ADDENDUM #2	06/29/2026
Revisions:	Date:

Drawing Title: BASEMENT MECHANICAL PIPING PLAN

Project Title: REPLACE STEAM BOILERS

Drawing Number: MP100

F5 MECHANICAL NEW PLAN - BASEMENT

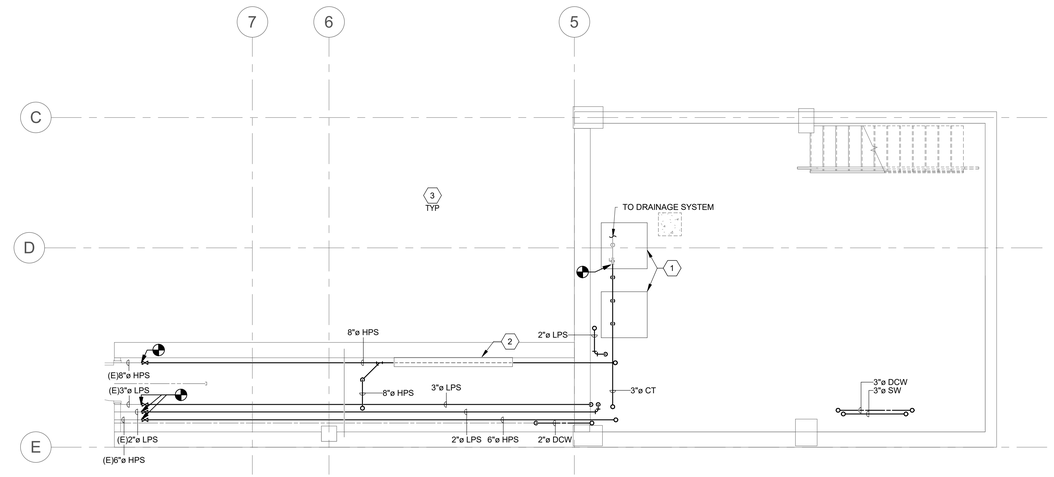
1 REPLACE EXISTING SUMP PUMPS. EXISTING WASTE PUMP TO REMAIN.

2 CONTRACTOR TO INSTALL NEW PRV STATION. INSTALL 1/3 VALVE FIRST. INSTALL 2/3 VALVE AFTER NEW 1/3 VALVE IS OPERATIONAL AND SUBMIT PLAN FOR APPROVAL TO REDUCE DOWN TIME.

3 CONTRACTOR SHALL INCLUDE IN BID REPLACEMENT OF ALL EXISTING PIPE HANGERS WHERE PIPE IS BEING REPLACED.
